Authorized Field Change

AFC G-06920

Subject: Transmission Clean Power and Ground Rewire

Figure 1

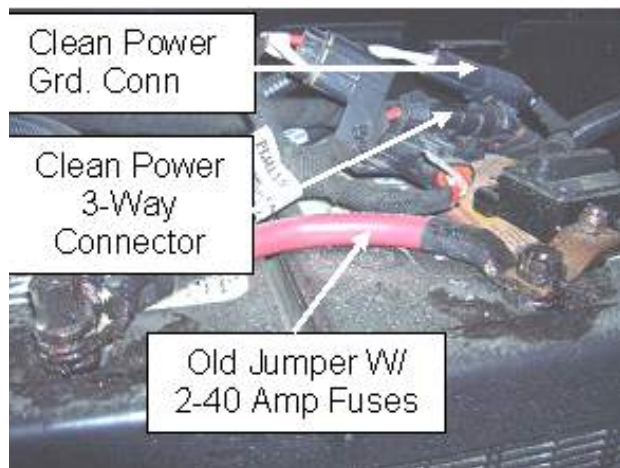
2. Unplug the 3-way connector from the positive clean power harness and the 2-way clean power ground connector in the battery box. See Figure 1.

3. Remove the clean power jumper cable from the positive battery terminal(s). See Figure 1.
4. Install the new 3-way clean power harness and jumper (8000888R91) shown in Figure 2 to the battery positive terminals. Make sure the new jumper cable/harness has two 40 amp fuses and the TRANS ECU FEED CONN has a 30 amp fuse.
5. Locate the transmission 24-way 4705 connector located between the engine valve cover and the steering column as shown in Figure 3. The correct connector half will have Circuit J14AW (red) in cavity 13.

Figure 4

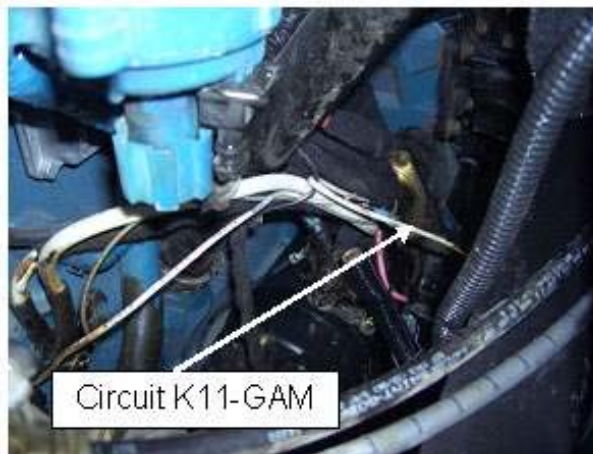
12. Locate circuit K11– GAM (white) on the engine block ground stud opposite the starter motor. See Figure 4.
13. Cut the ring terminal from K11–GAM and route the wire to the 2–way connector on the end of the red 12 gauge wire.
14. Strip the end of K11–GAM, insert it into cavity B of the new 2–way connector and install terminal 1661708C1 (pull to seat).
15. Feed the new harness 2–way connector (circuits N92A and N92–G) from the bottom of the engine compartment up and connect to the newly installed 2–way connector.
16. Remove the original 3–way clean power harness and the 2–way ground from the battery box and from the 3–way clean power and ground connection at the starter. Discard the old harness. See Figure 5.

Figure 10

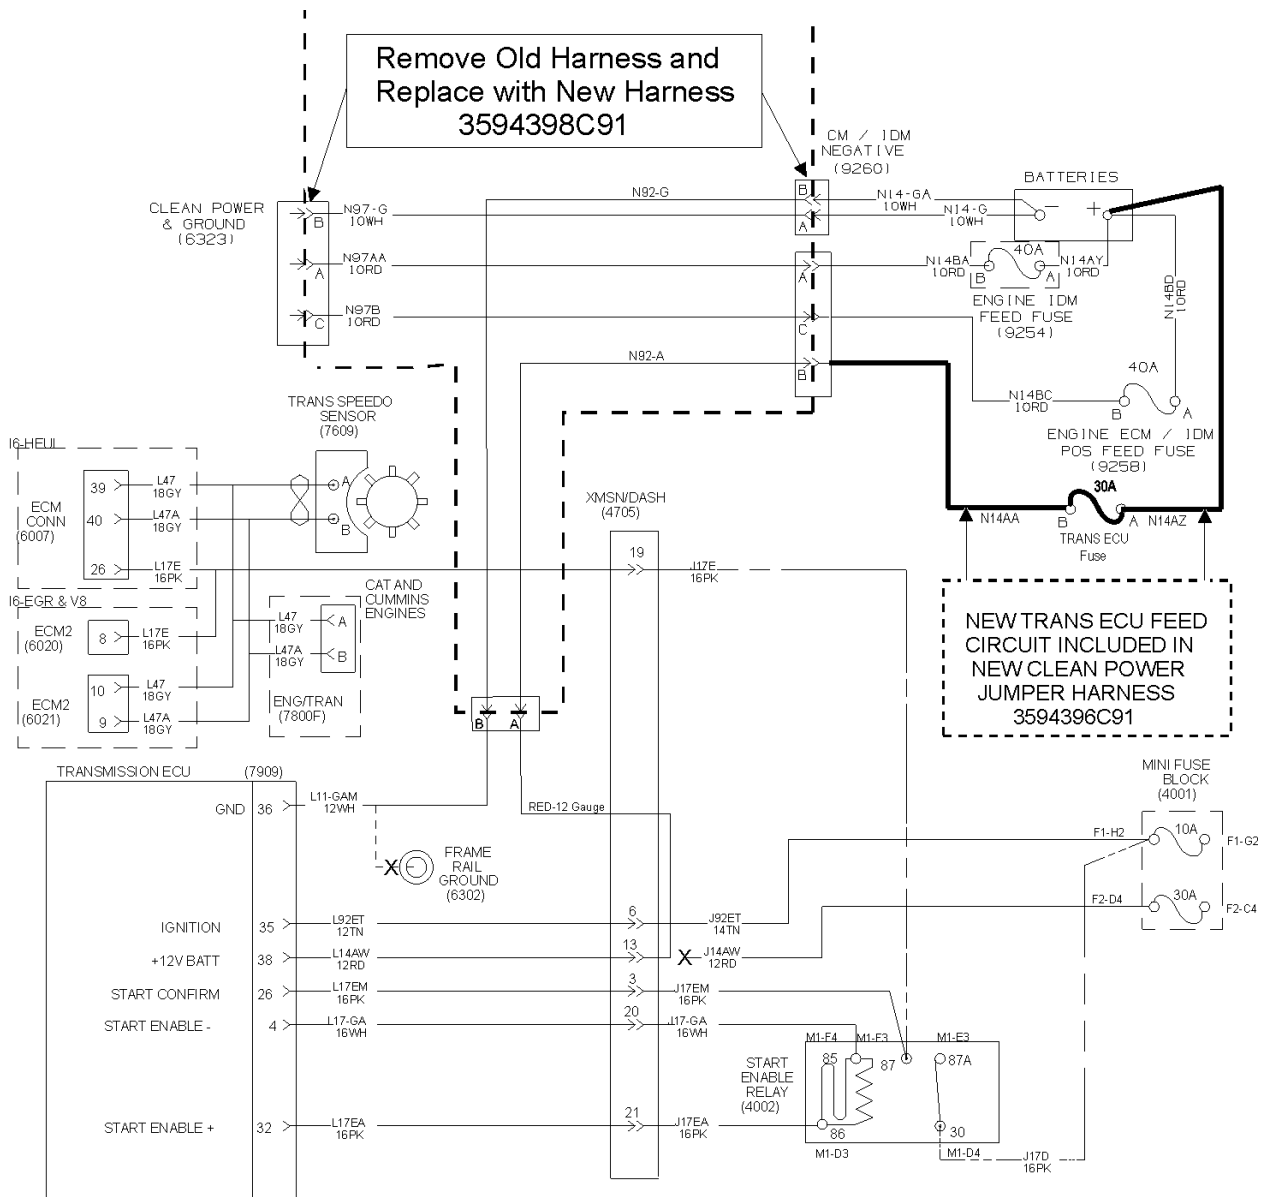
Deterioration of the current power feed to the transmission ECU can experience low voltage that can ultimately cause a No Start condition. Supplying power and ground directly from the batteries to the transmission ECU will eliminate the voltage losses being experienced through the frame rail ground and various chassis connectors. The circuit schematic on the last page illustrates the final wiring after the modifications are completed.
